City of Mississauga Department Comments

Date Finalized: 2022-09-07	File(s): A319.22
To: Committee of Adjustment	Ward: 9
From: Committee of Adjustment Coordinator	Meeting date:2022-09-15 1:00:00 PM

The applicant requests the Committee to approve a minor variance to allow the construction of a below grade entrance proposing a side yard setback of 0.15m (approx. 0.49ft) to the stairs, stairwell and retaining wall facilitating the below grade entrance; whereas By-law 0225-2007, as amended, requires a minimum side yard setback of 1.20m (approx. 3.94ft) to stairs, stairwell and retaining wall facilitating the below grade entrance in this instance.

Property Address: 5403 Quartermain Cres

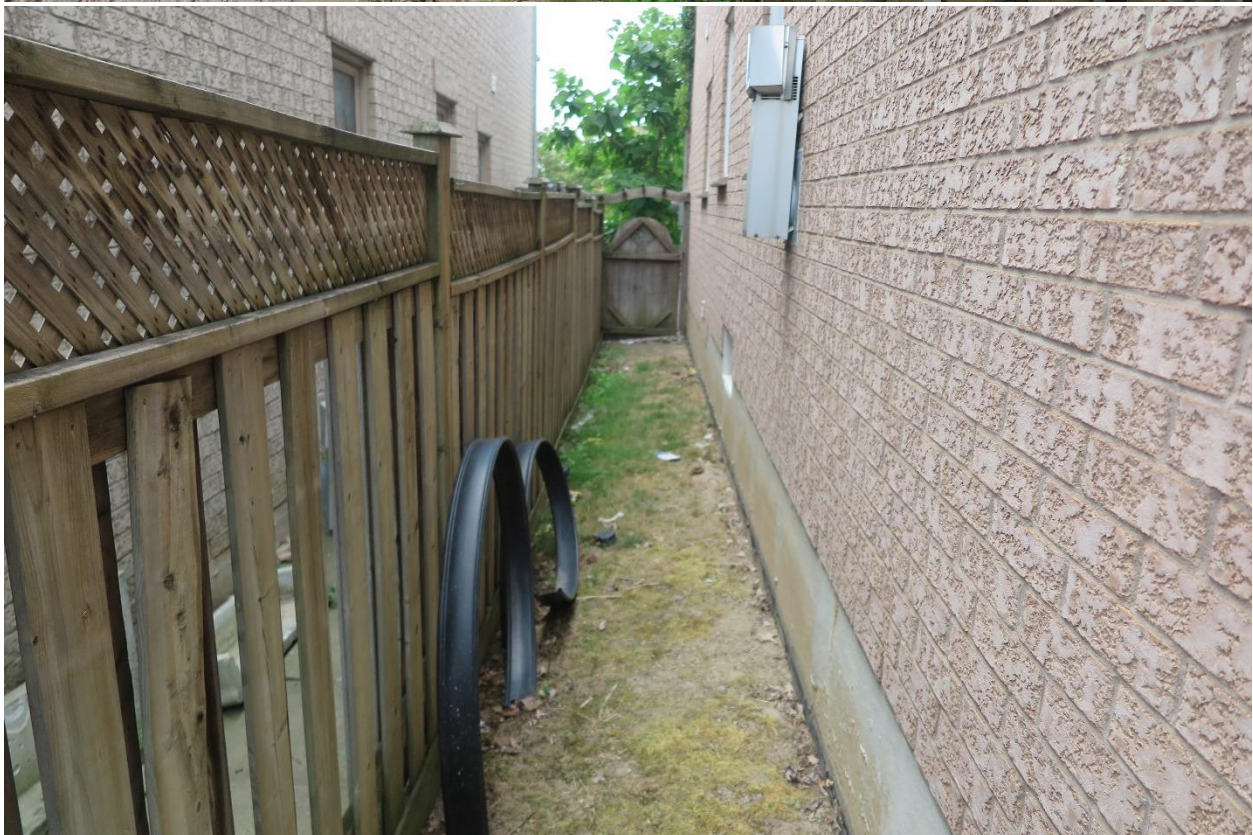
From our site inspection and the enclosed photos, we observed that there is some drainage from the rear yard that currently drains through the area of the proposed below grade entrance which could be addressed with some minor regrading in the area.

In view of the above it is suggested that the applicant re-consider the location of the proposed below grade entrance at the proposed location, or alternatively consider an entry location at grade which does not require any outdoor steps.

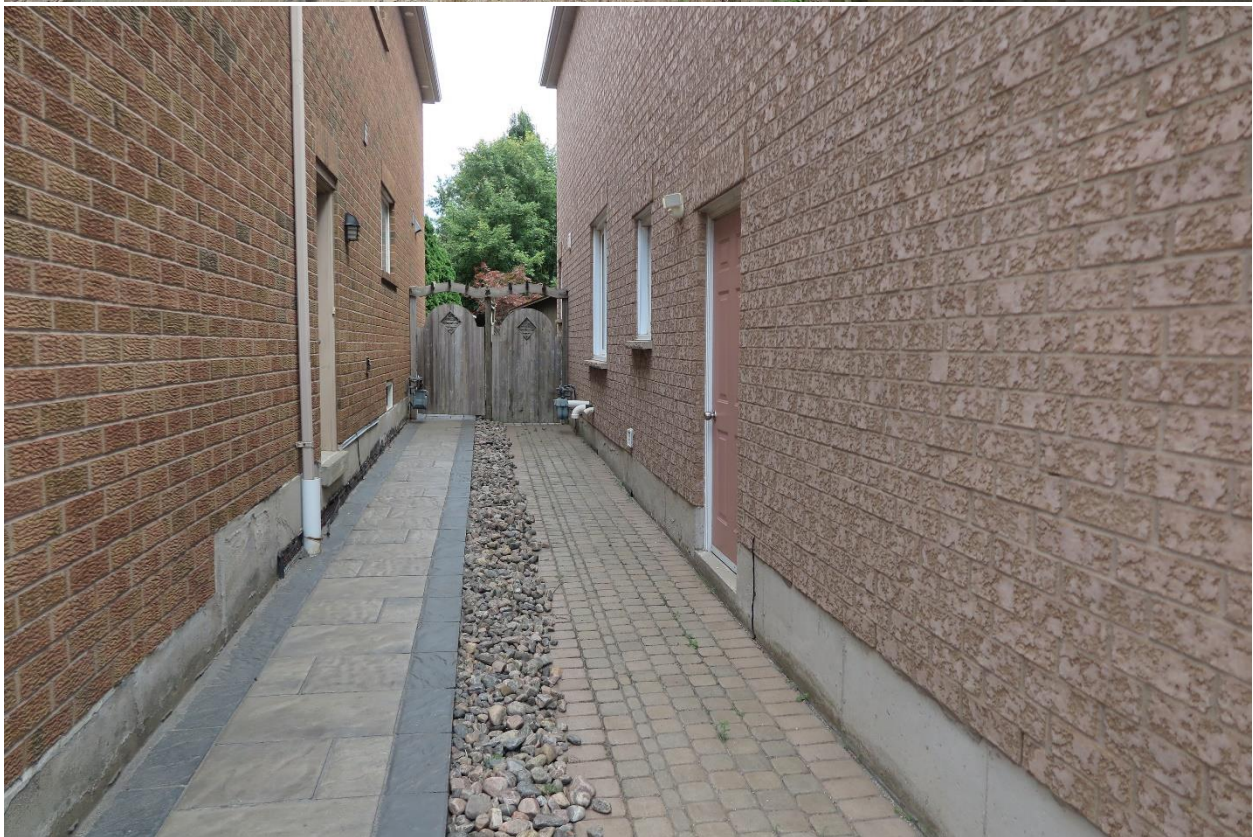
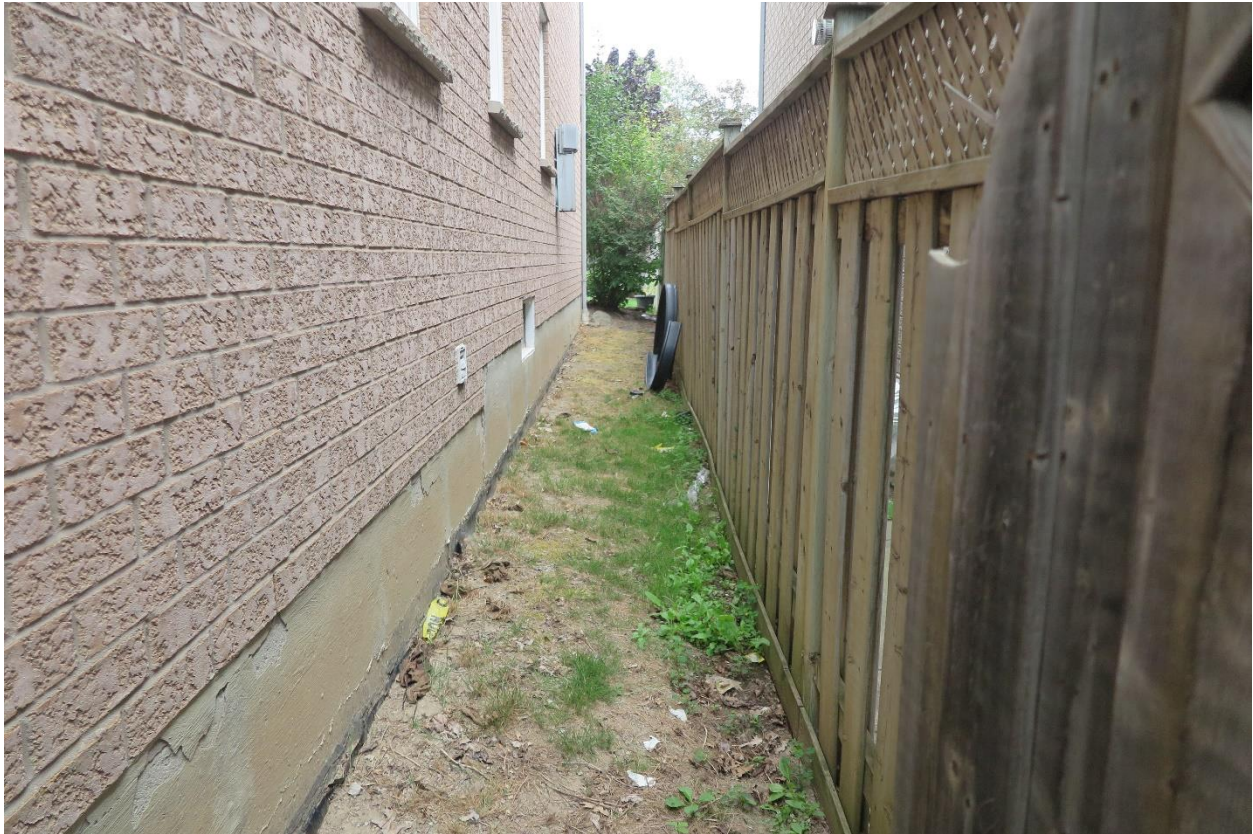
Our concerns with the request is that the information submitted is somewhat misleading as the applicant is proposing a 0.15M setback (approx. 0.49ft) which in itself is inadequate to allow for a side yard drainage swale, however, the reduced setback does not take into consideration the proposed retaining wall. As shown on one of the drawings submitted, the significant sized retaining wall is proposed to be constructed abutting the property line which would likely result in a 0.0M setback.

More problematic than having a 0.0M setback, the constructing a retaining wall abutting the property line would require the removal of the existing fence and permission for any excavation on the abutting property. In this regard, the applicant's proposal should include the approval from the abutting neighbour to address both, arrangements for the fence modifications required and also for the approval to allow excavation on their property to construct the retaining wall.

In addition to the above, we also note that constructing a walkway connection in the area of the front of the dwelling may also be problematic due to the grade differential which currently exist in the area, this can be seen in one of the photos.
